CHANGE ORDER NO 2 - WHALES TOOTH PARKING LOT

ELECTRICAL DETAILS - 1

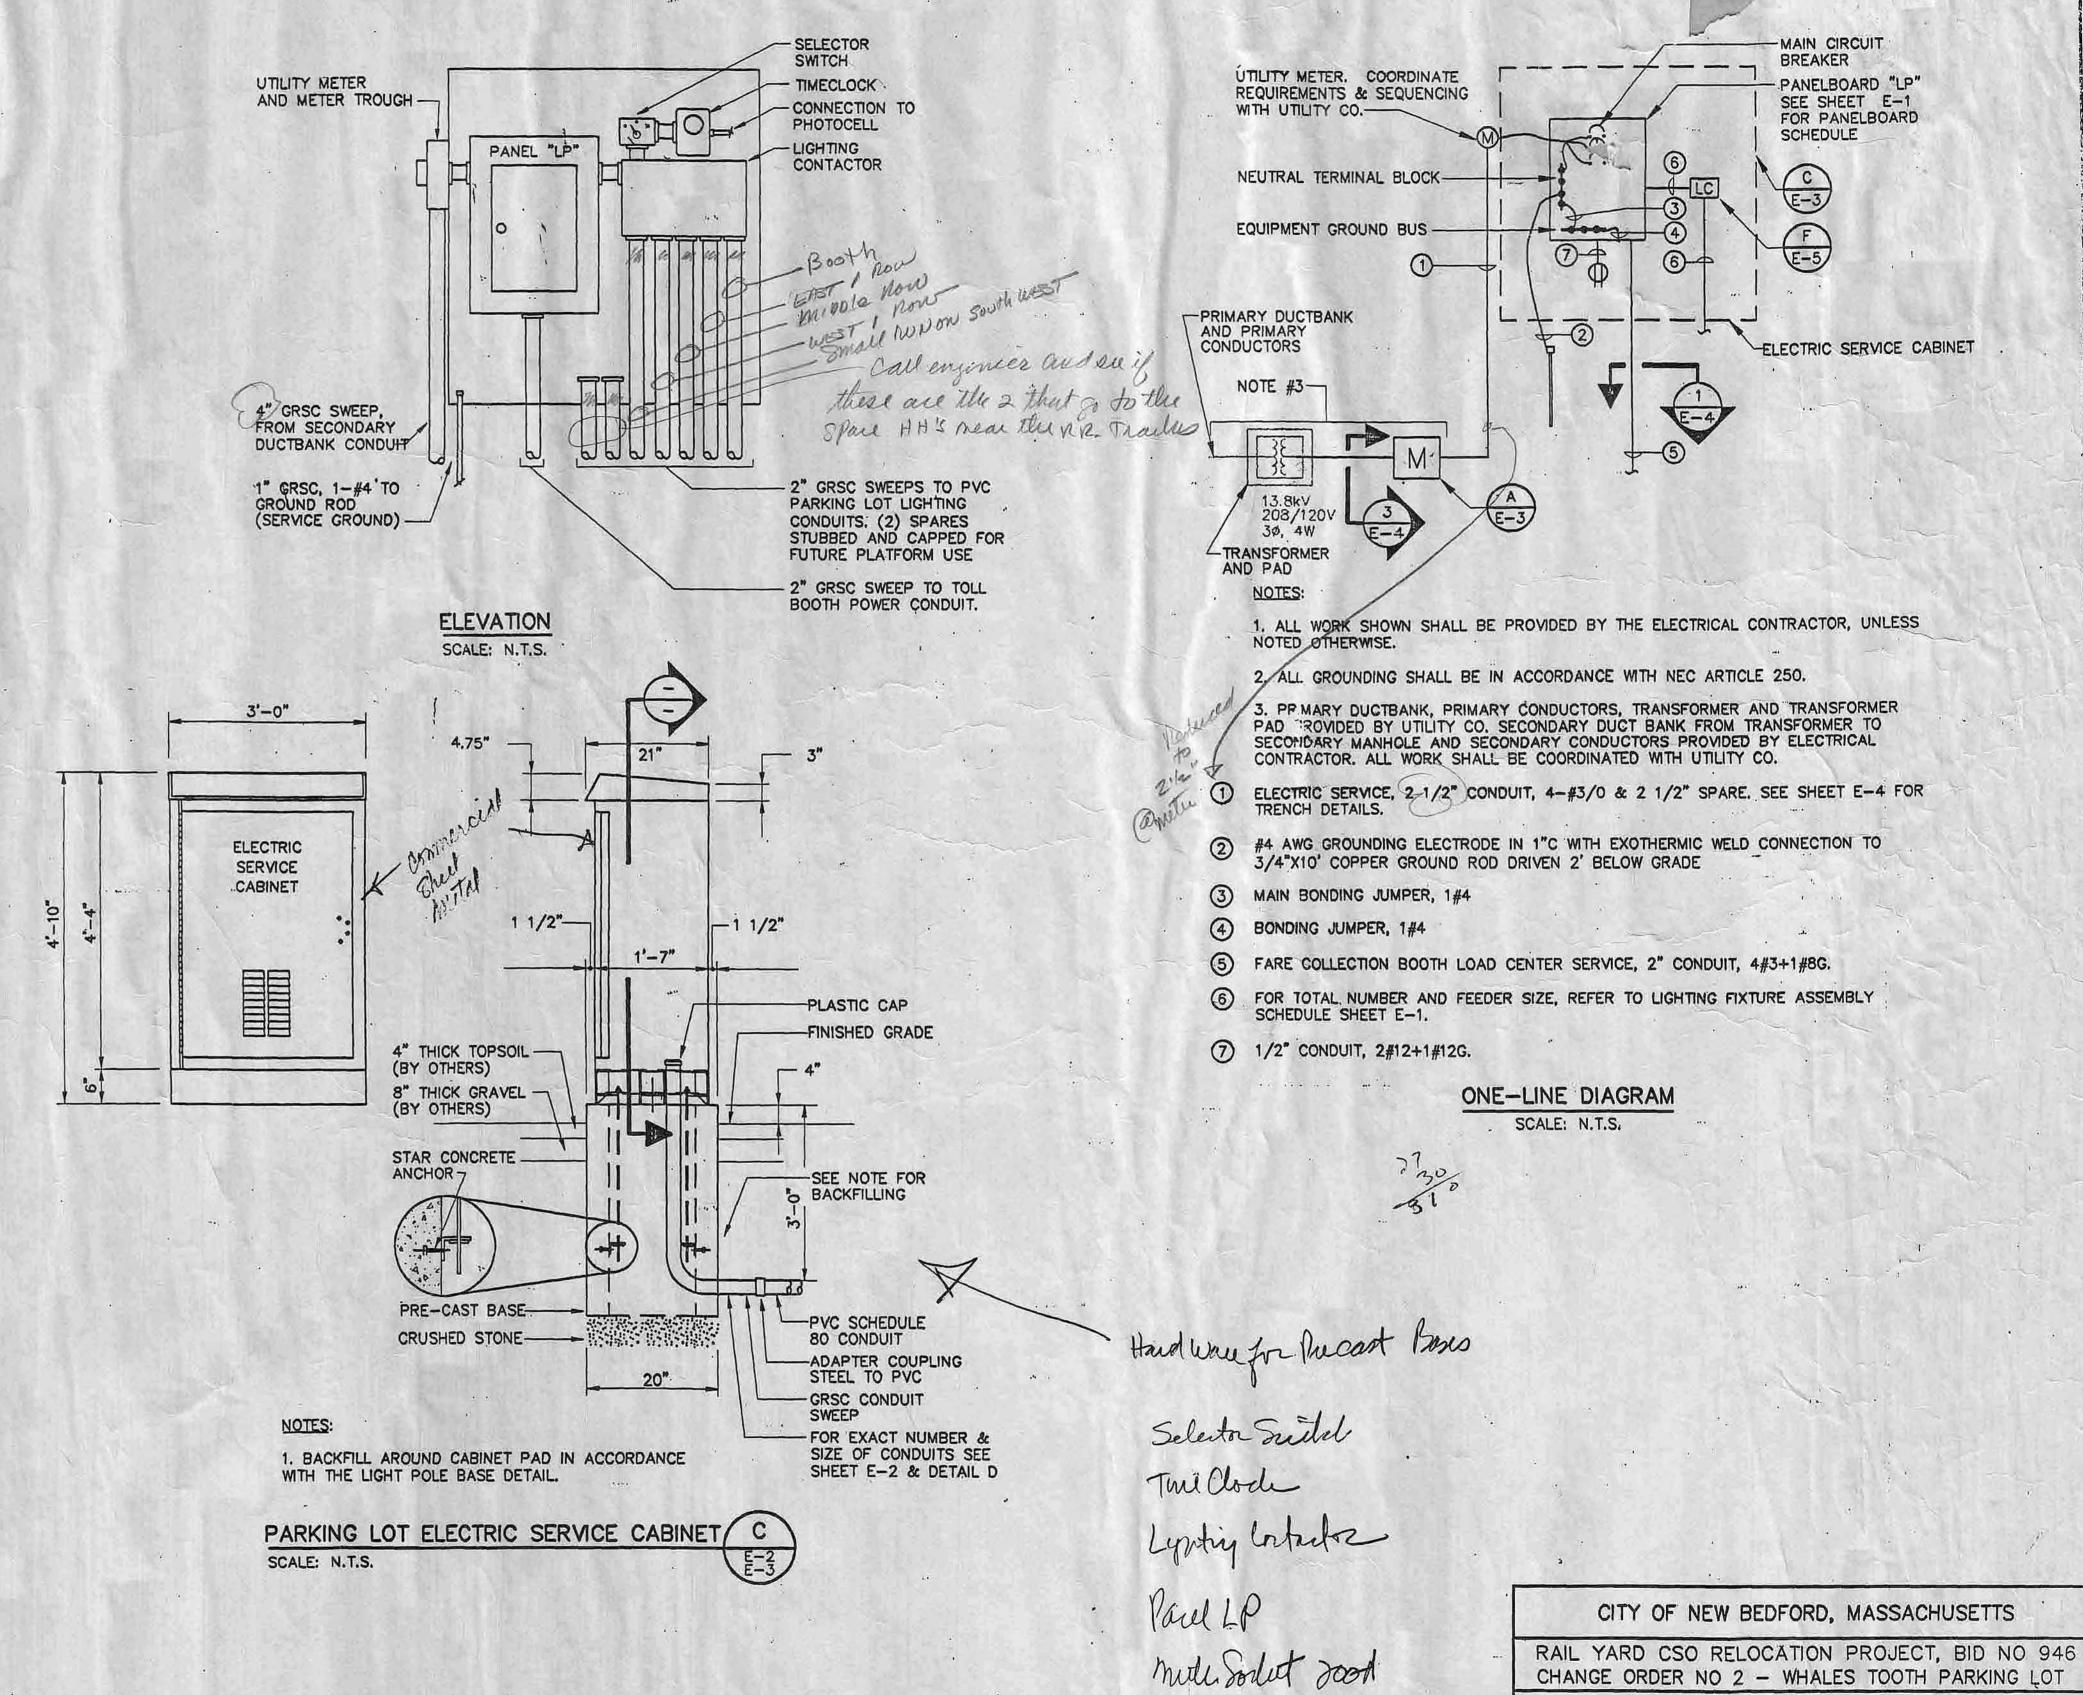
- INSTALL GALVANIZED PULLING EYES, ONE ON EACH WALL (4) 3/4" EYES.
- √ 2. CONCRETE TO BE 5000 PSI HIGH EARLY STRENGTH.
- CONDUIT OPENING TO HAVE 4" BELL ENDS FLUSH WITH INSIDE WALL.
- 4. DO NOT BURY MORE THAN 18" BELOW FINAL GRADE.
- √5. TO BE INSTALLED ON A 12" BED OF CRUSHED STONE.
- 6. MANUFACTURED BY FRUEN CAT # FE-3A, LINHARES 6-4 OR EQUIVALENT, AS APPROVED BY UTILITY CO.
- 7. TRENCH AND BACKFILL IN ACCORDANCE WITH THE PRECAST POLE BASE DETAIL

- 1. COVER ENGRAVING SHALL BE COORDINATED WITH UTILITY CO.
- 2. FRAME & COVER TO SUPPORT H20 WHEEL LOAD.
- 3. NO VAULT MANHOLE SHALL BE BURIED DEEPER THAT 18" BELOW FINISH GRADE.
